## Addendum No. 3

**Project:** USC Hamilton College Renovation  
**Project No.:** U-651-07  
**State Permanent Improvement Project No.:** H27-9905-SG  
**Date of Issue:** May 8, 2014

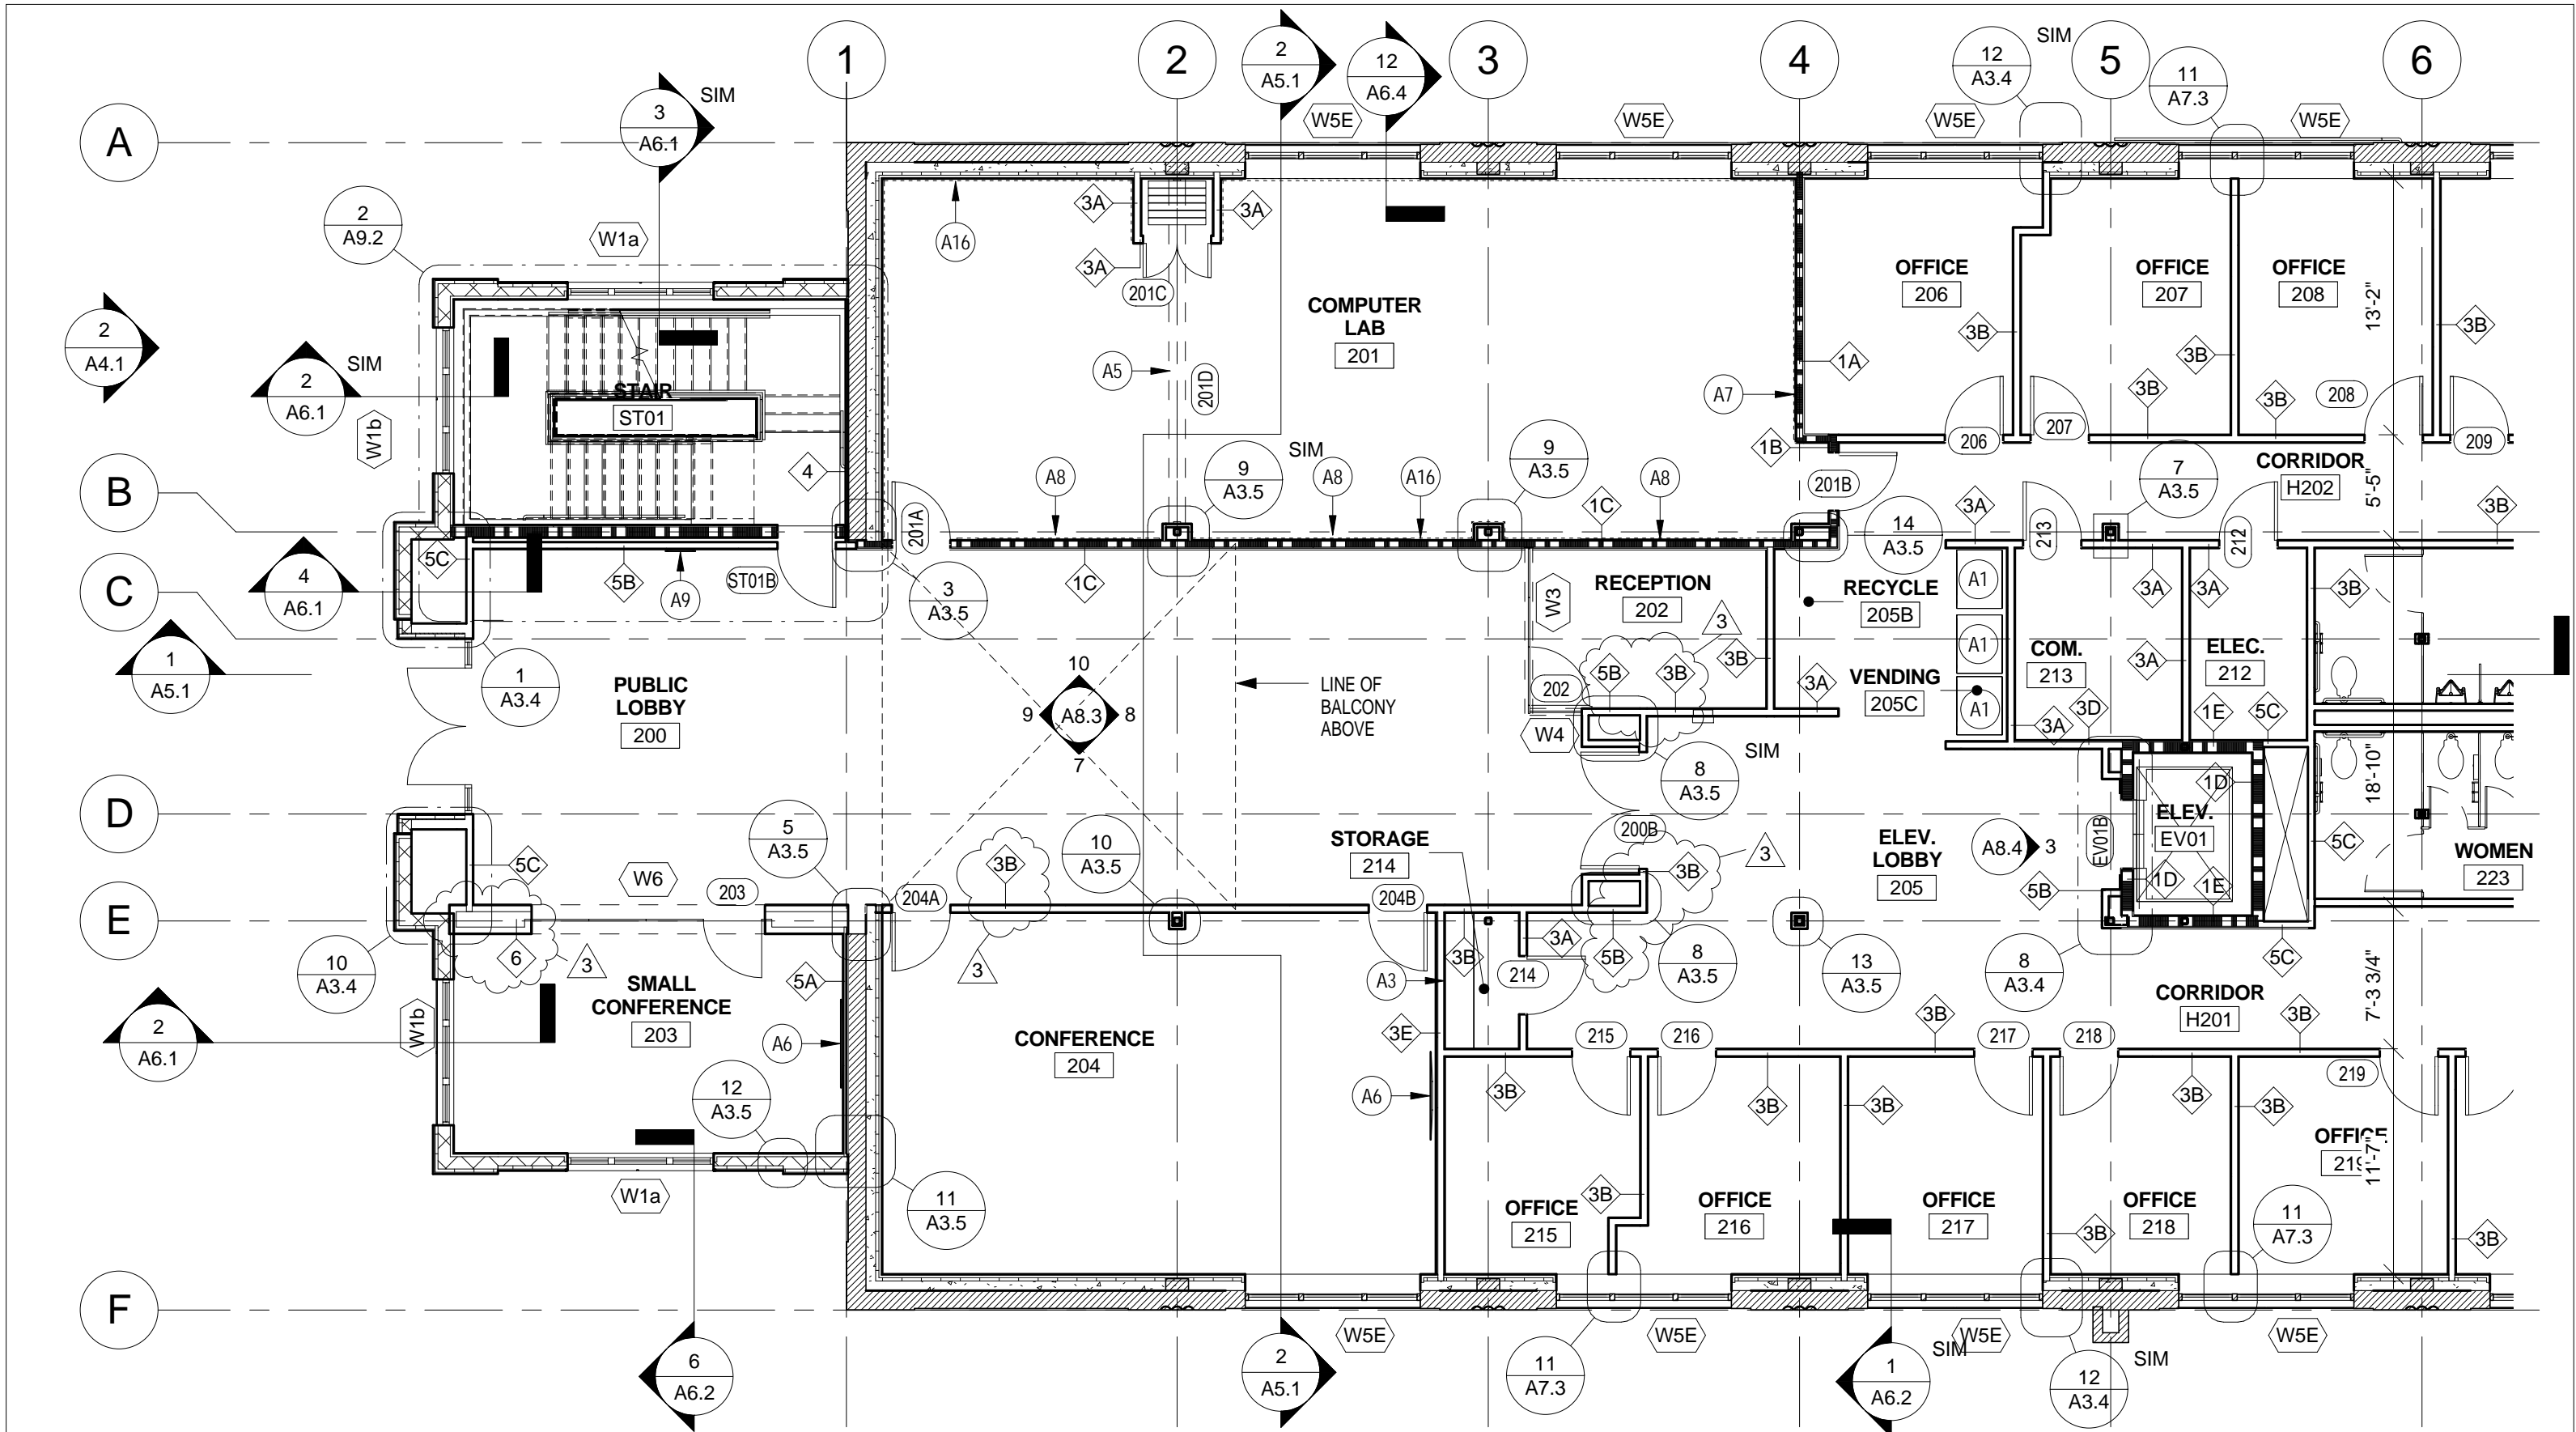
1. Sheets A1.3, A1.2, A3.4, A3.5, and A7.1 – Remove the fire rating and revise wall types as shown on the attached sketches SK-A-05 and SK-A-06. See sketches SK-A-07, SK-A-08, SK-A-09, SK-A-10 for revised plan details. See sketch SK-A-11 for revised door schedule for doors 200B, 204A, 204B, 301, 302, 303, 323, 324, 325, H302, and H303. See sketch SK-A-12 for revised wall type 6.
2. Sheet A3.2 – Add the following note: "All Toilet Tissue Dispensers, Soap Dispensers, and Towel Dispensers will be supplied by the owner and installed by the contractor."
3. Sheet A3.2 – Under Typical Toilet Accessory Mounting Requirements for Type mark M-1: Replace the word "Frameless" with "Stainless Steel Frame". See specifications for size requirements.
4. Sheet A7.3 – See window schedule below for frame detail identifications at window W8E:

MECHANICAL SITE PLAN

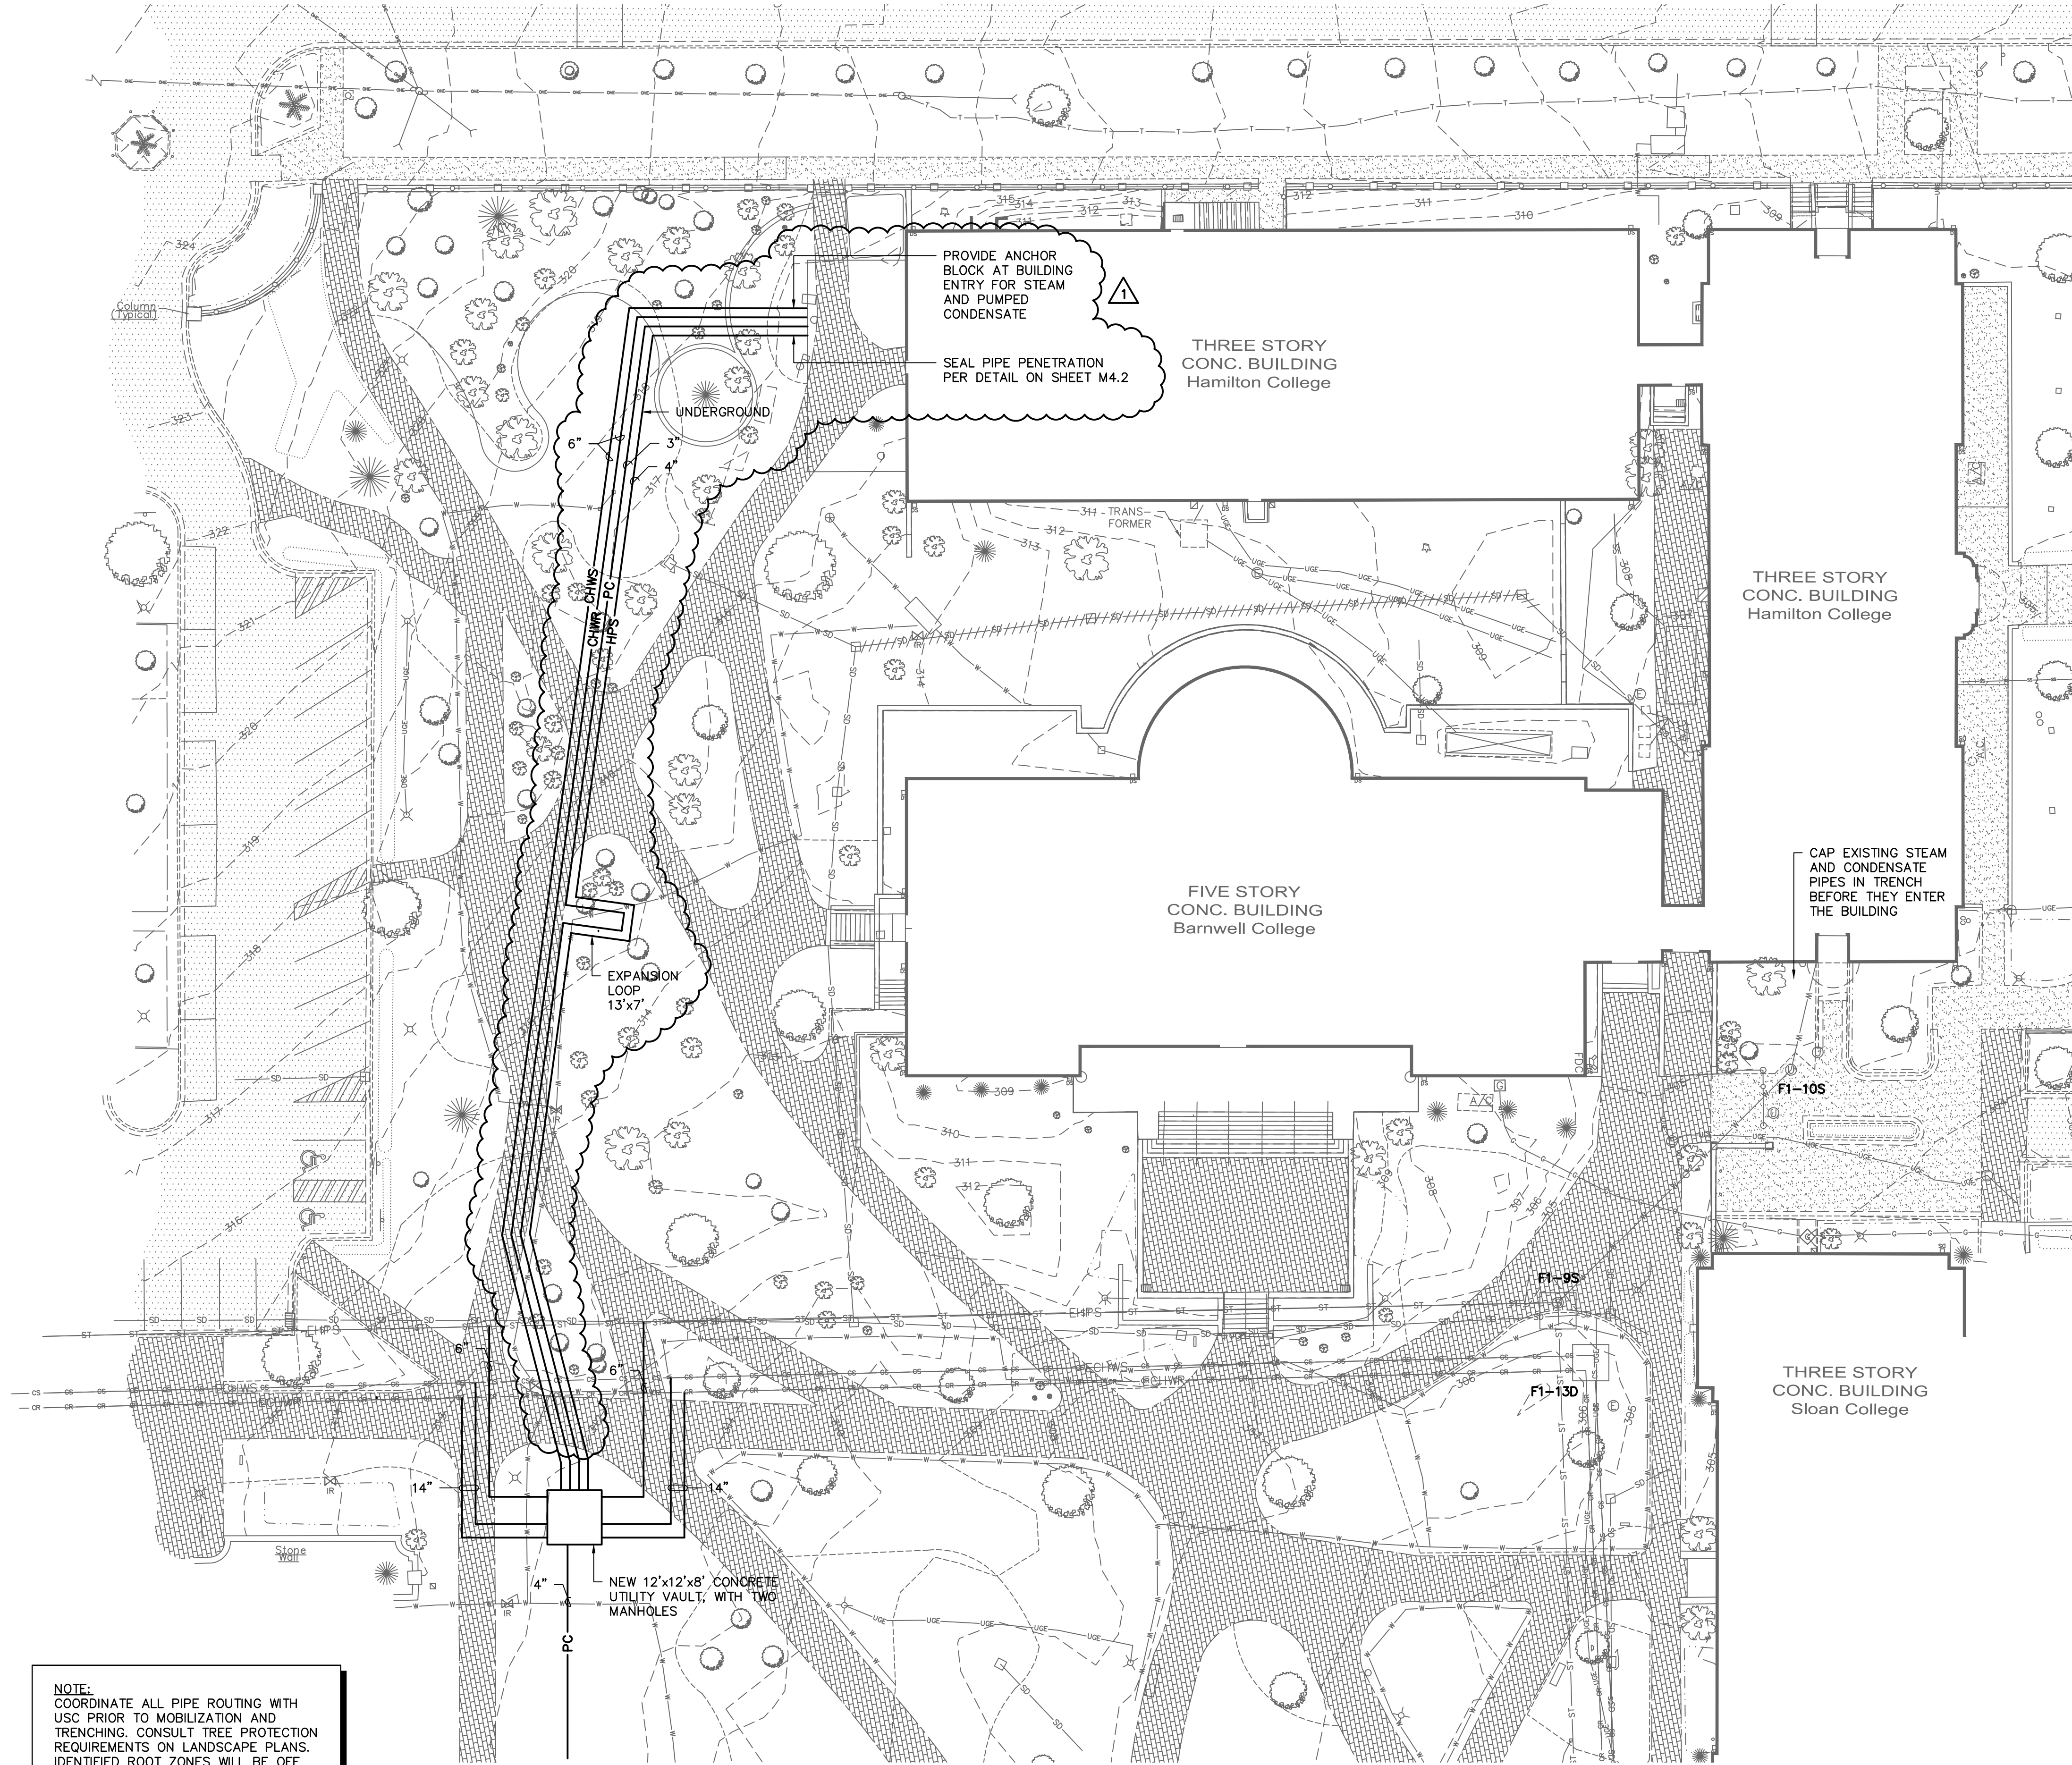
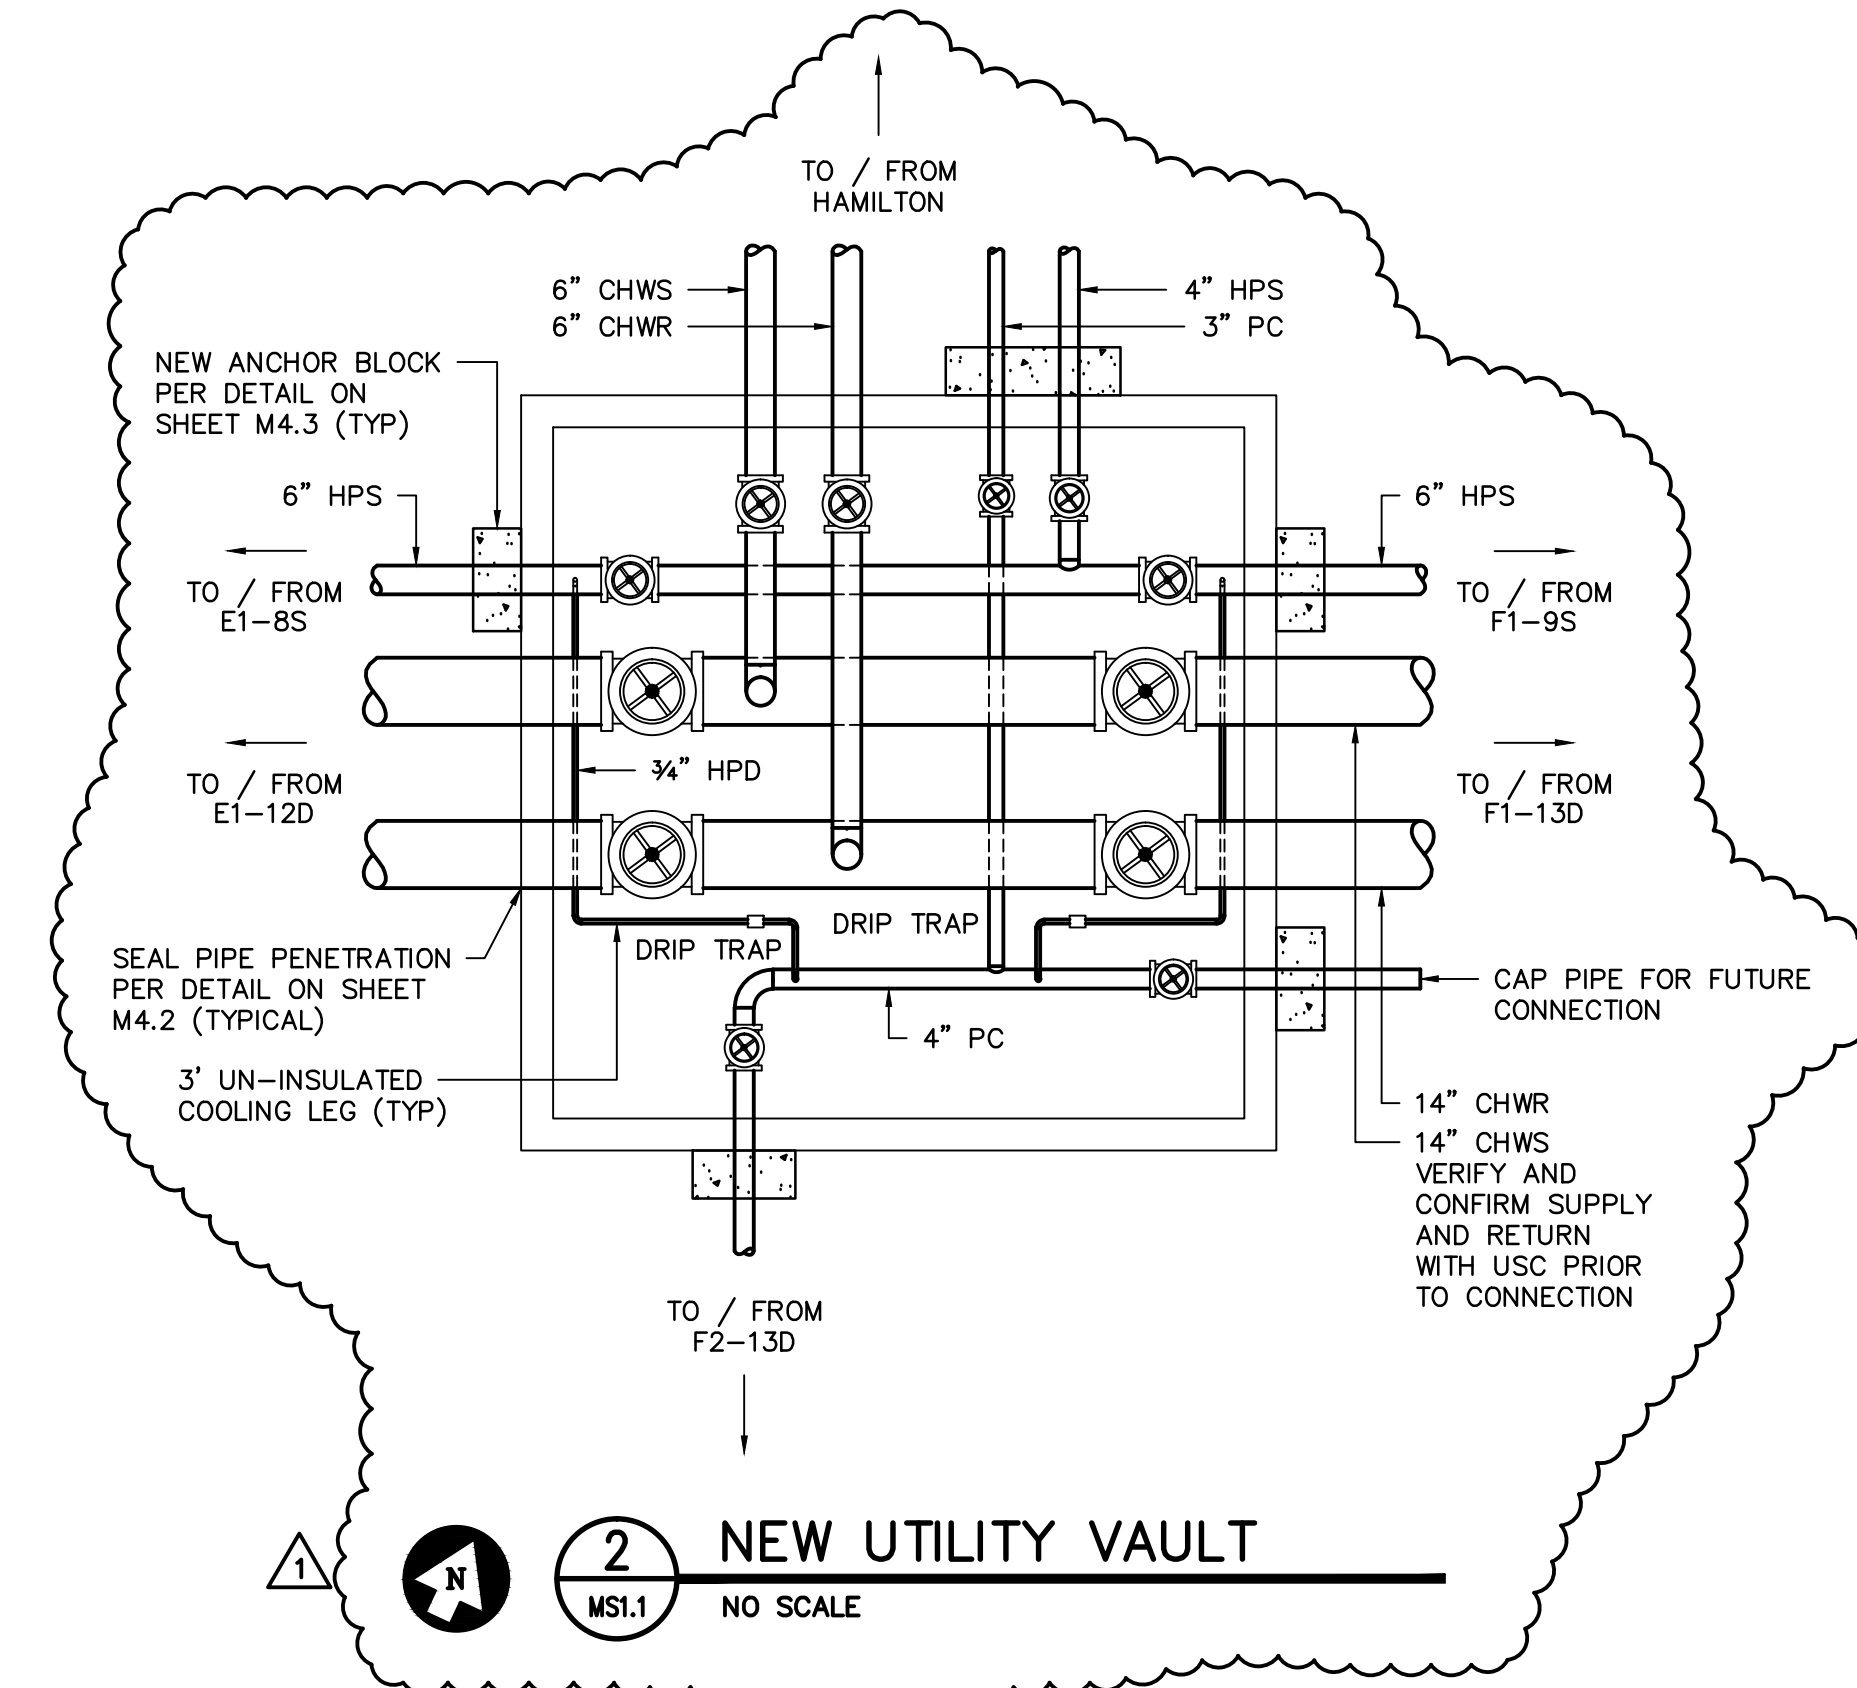
1. Sheet MS1.1, Mechanical Site Plan – See revised drawing MS1.1. This revised drawing revises the routing path for the chilled water, steam and condensate pipes.
2. Sheet M1.1, First Floor Plan – See revised drawing M1.1. This revised drawing shows the carbon dioxide sensor locations.
3. Sheet M1.2, Second Floor Plan – See revised drawing M1.2. This revised drawing shows the carbon dioxide sensor locations.
4. Sheet M1.2, Second Floor Plan – See revised drawing M1.2. This revised drawing removes the fire dampers at the Atrium where the fire rated wall is removed.
5. Sheet M1.3, Third Floor Plan – See revised drawing M1.3. This revised drawing shows the carbon dioxide sensor locations.
